BELMORE SPORT & RECREATION PRECINCT

MASTERPLAN REPORT

20. MARCH. 2019
FINAL REPORT

FINAL MASTERPLAN

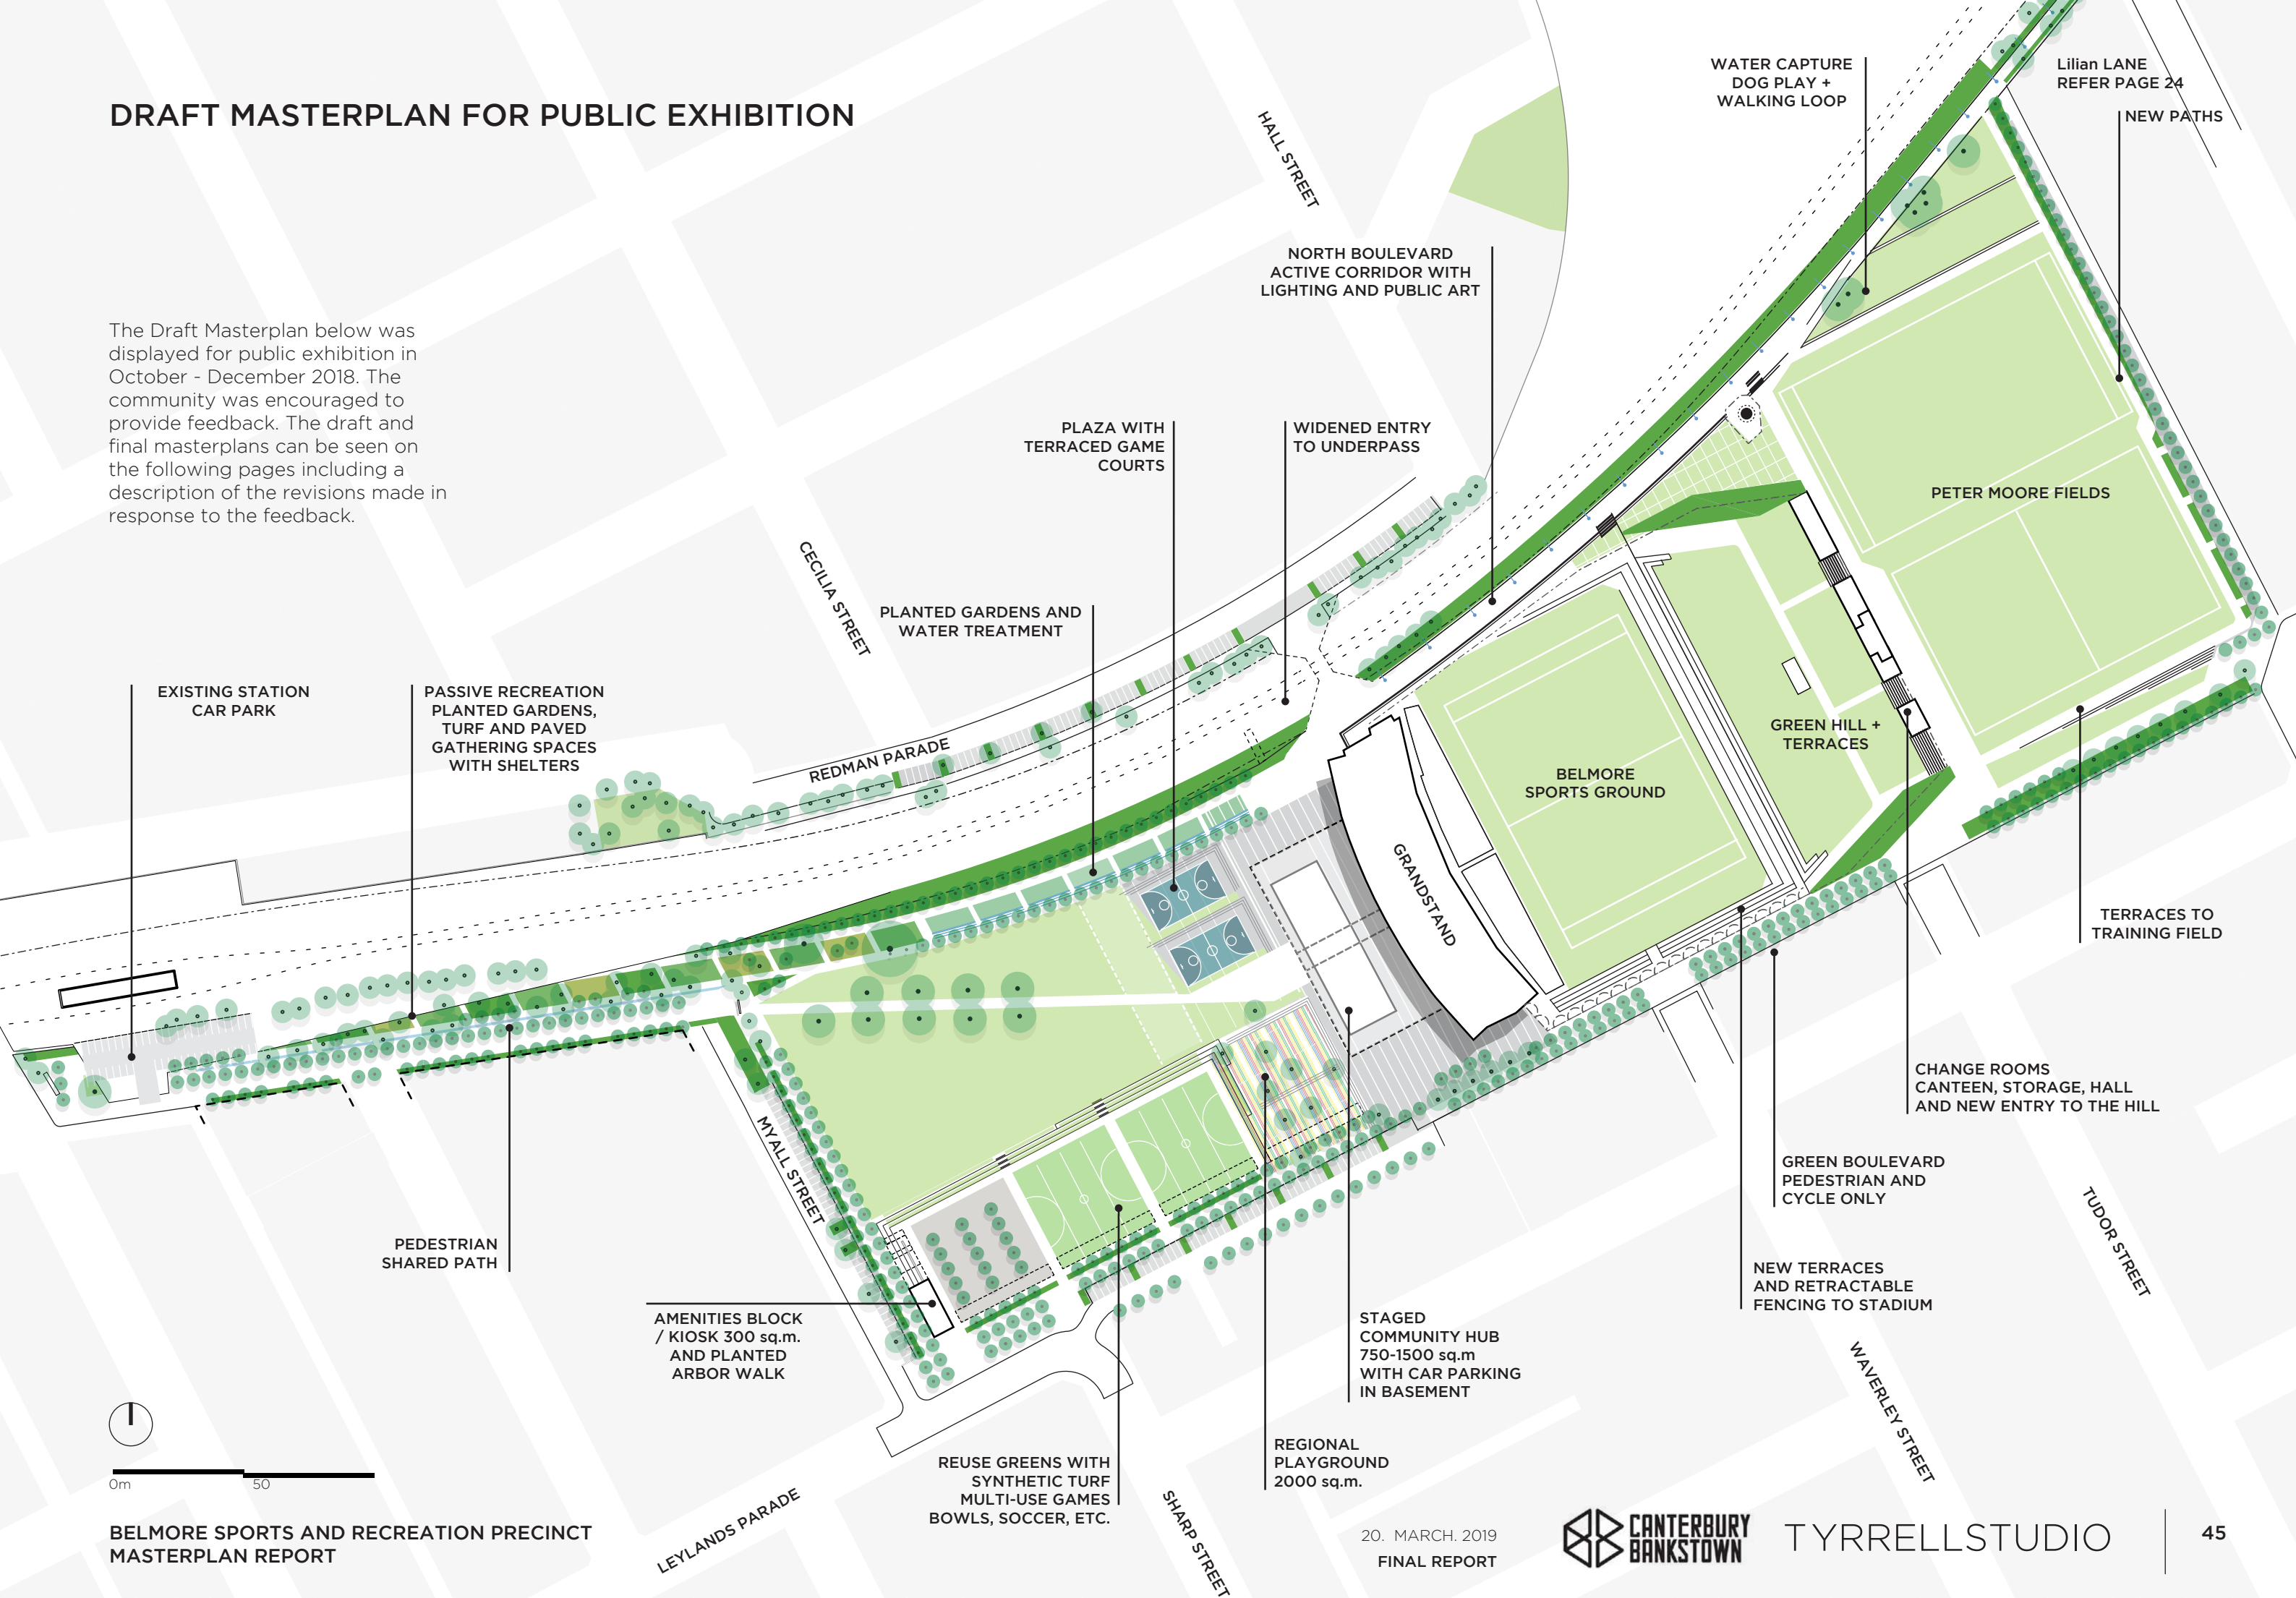
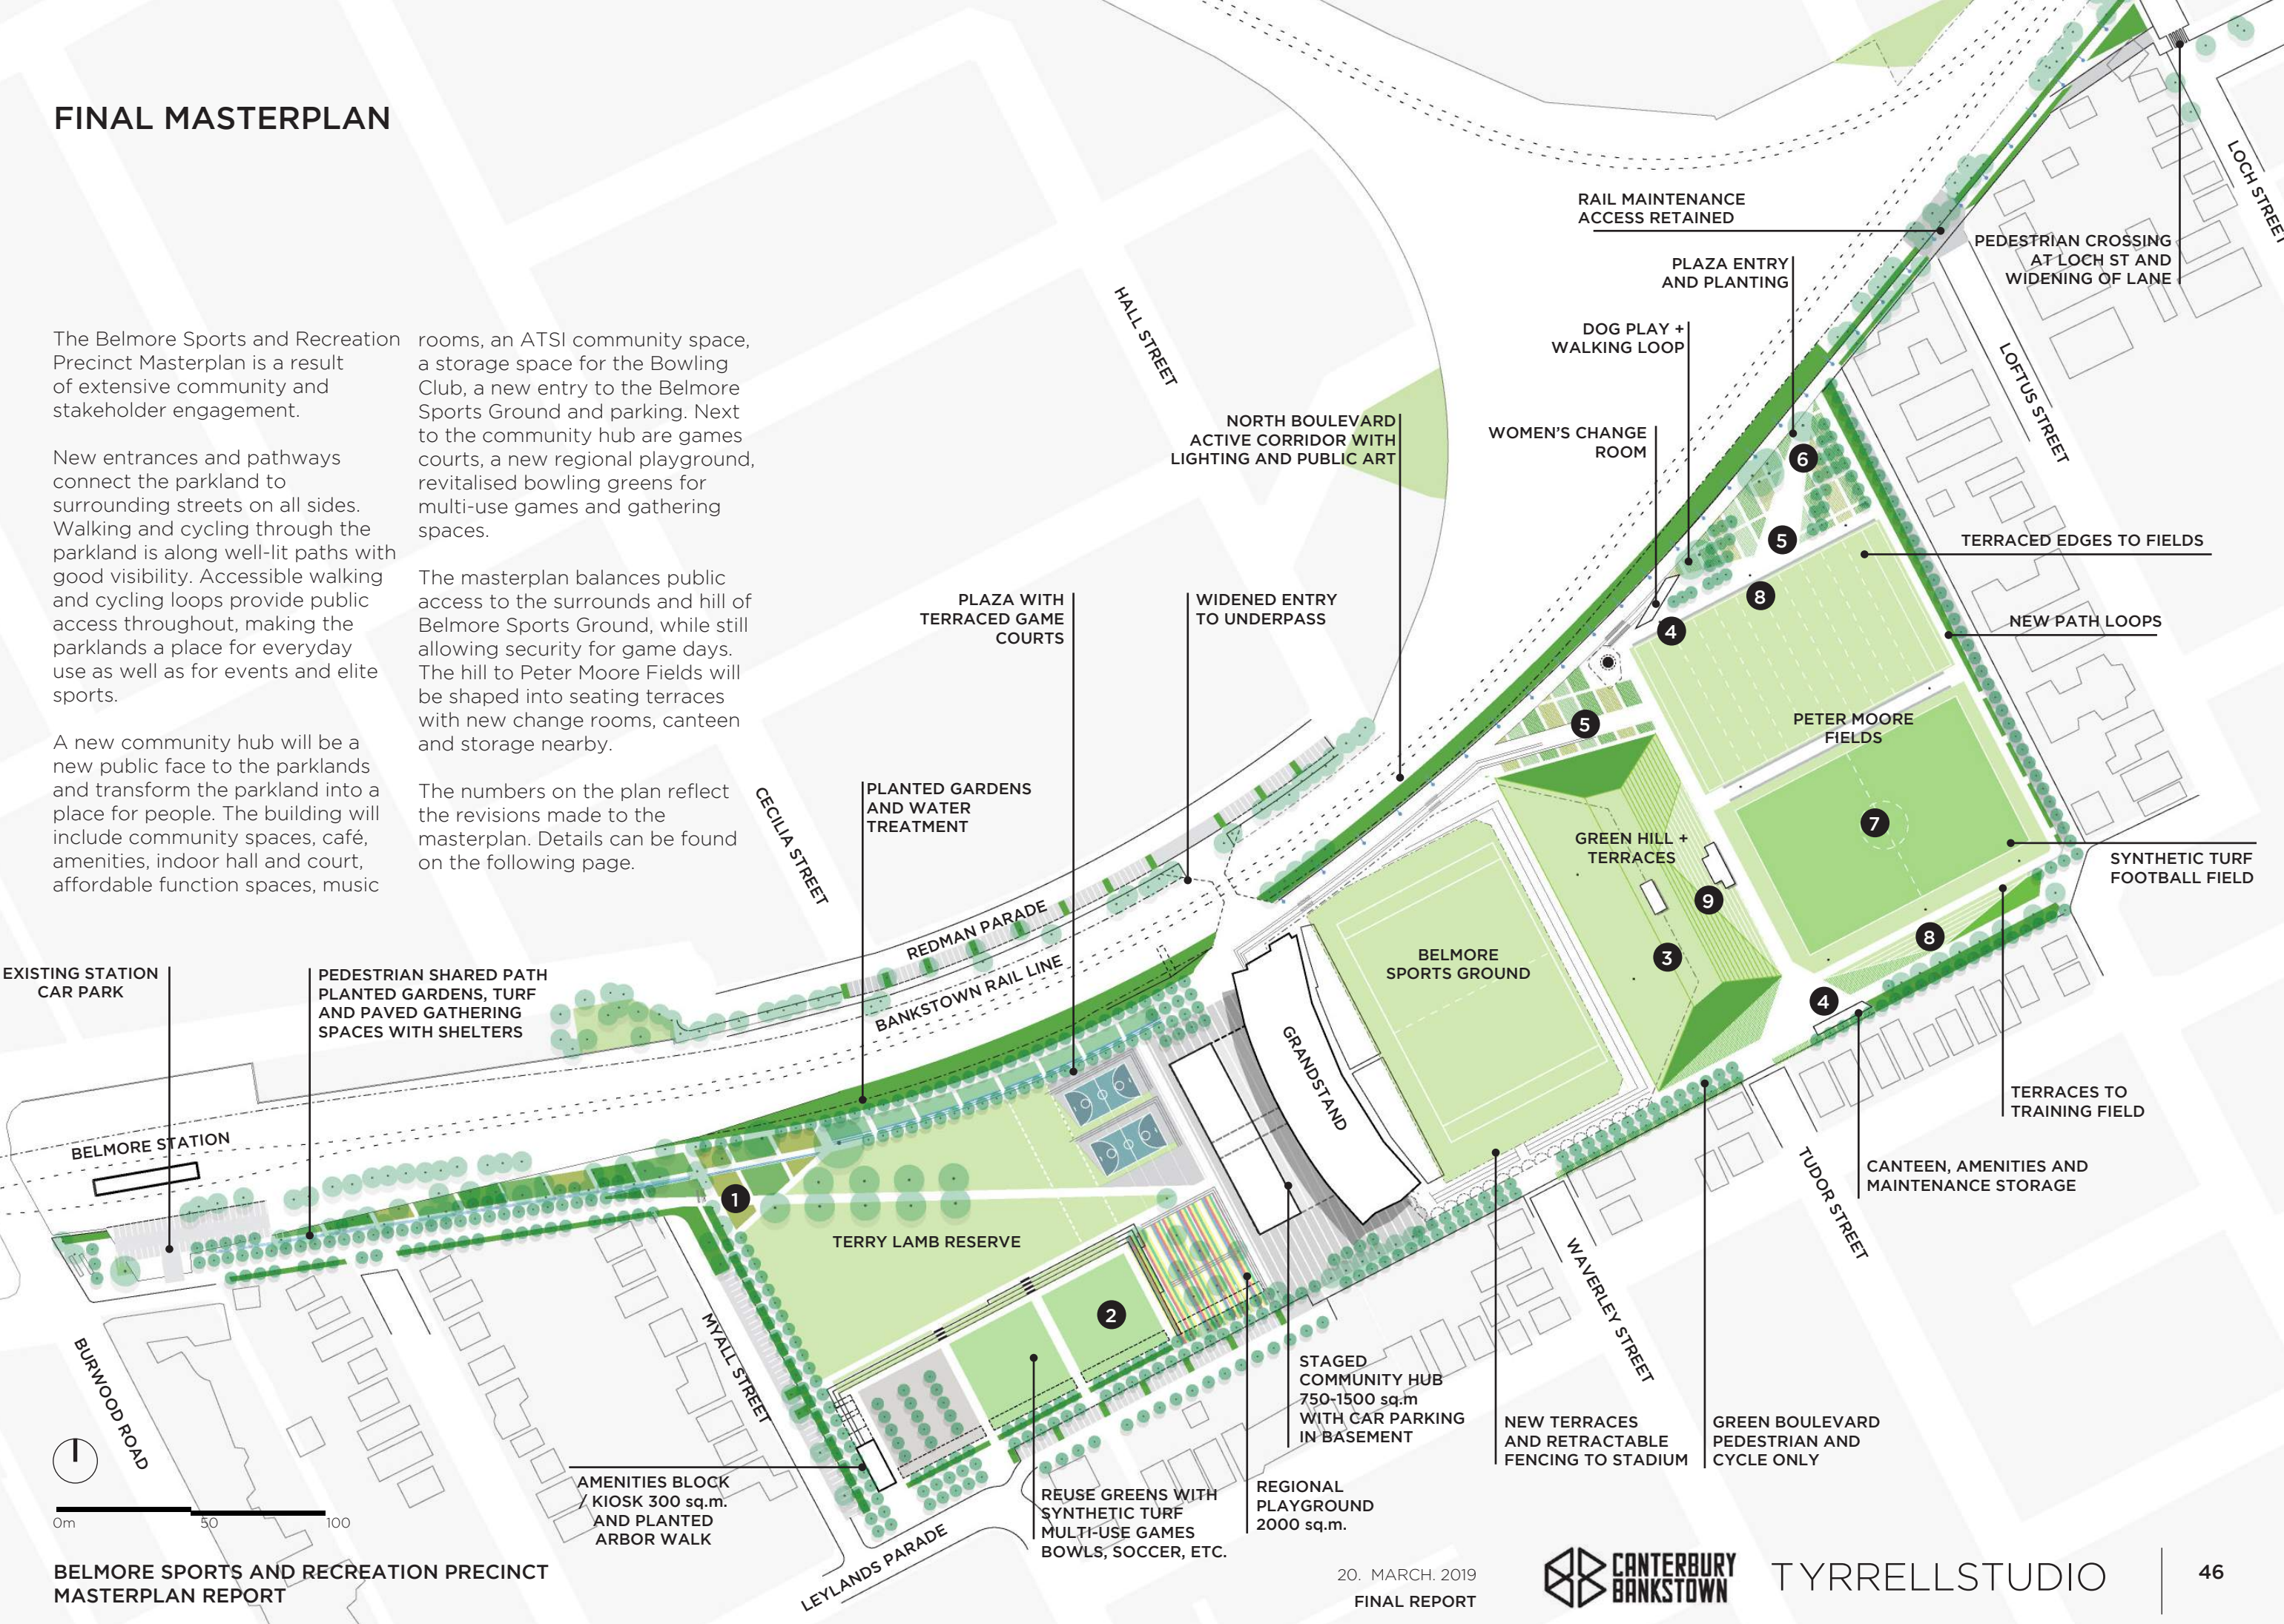
NUMBER	ITEM	REASON
1	Additional planting and paths at Cotter Entrance	Further refinement of the design to create a clear entrance into the park that complements the heritage character of the entry and Avenue.
2	Bowling Greens sports lines removed.	These courts are intended to be for community use, for informal use and low key non-competitive events. Some members of the community thought the lines meant these courts were intended for competitive sports, so the lines have been removed to prevent this confusion.
3	Belmore Sports Ground hill fence alignment changed.	Feedback from consultation included the desire to use the side of the hill facing Peter Moore Fields publicly and be outside the fence of the Sports Ground. This idea reinforces the design principles of balancing sports and community uses. This change would not impact the usable size of the hill for Belmore Sports Ground. A new amenities block has been added on the Belmore Sports Ground side, adjacent to the main screen.

4	Change rooms, Canteen, Amenities and Storage rooms around Peter Moore Fields adjusted.	Feedback from consultation included the desire to use the side of the hill facing Peter Moore Fields more publicly. The buildings have been relocated from the base of this hill to maximise connection between Peter Moore Fields and the hills. The supporting buildings have been carefully sited near the fields while not impacting the major pedestrian and cycle paths or sight lines through the area.
5	Access to Peter Moore Fields from the Belmore-Campsie Shared Path along the rail line is accessible and cycle-able.	Feedback was received regarding disabled access and continuous cycle access from the rail line shared path into Peter Moore Fields. This has been provided from the north-east corner of the site near the dog park. A 1:20 walkway between the Belmore Sports Ground and the Communications Tower allows access from the west into Peter Moore Fields from the north side.

NUMBER	ITEM	REASON
6	Improved entry to the park from Campsie and improved off leash dog park.	The masterplan has been revised to provide an improved entry into the parklands from Lillian Lane at Peter Moore Fields. A planted grid of trees, planted garden and plaza space provides a generous civic entry into the park from this corner. This area has an off leash dog park carefully sited so that it complements the space but does not create a barrier between the rail line shared path and Peter Moore Fields.
7	Peter Moore Field South changed to a synthetic turf football field.	Feedback was received regarding the need for a synthetic football field at Peter Moore Fields South. The increased volume of use that a synthetic field can accept will allow this field to be shared by Sydney Olympic FC and the community. This will allow the closed fences to this area to be removed and the field to be shared in a managed way.

8	Improved seating, terraces and planting along the southern edge of Peter Moore Field South and North	Together with point 7, a refinement to seating and terrace arrangement along the southern edge of Peter Moore Field South has been made. This will allow for improved viewing and use of the field. Concrete terraces and planting will formalise the slope and an improved green boulevard will connect the parkland along its southern edge to Thorncraft Parade and Evaline St.
9	Terraced grass to the Peter Moore Fields Hill	In conjunction with feedback from point 4, the Peter Moore Fields Hill has been refined to have concrete terrace retaining walls with grass areas between them for informal viewing over the sports fields and passive use. The hill will be maintained as a large green area available for public use.
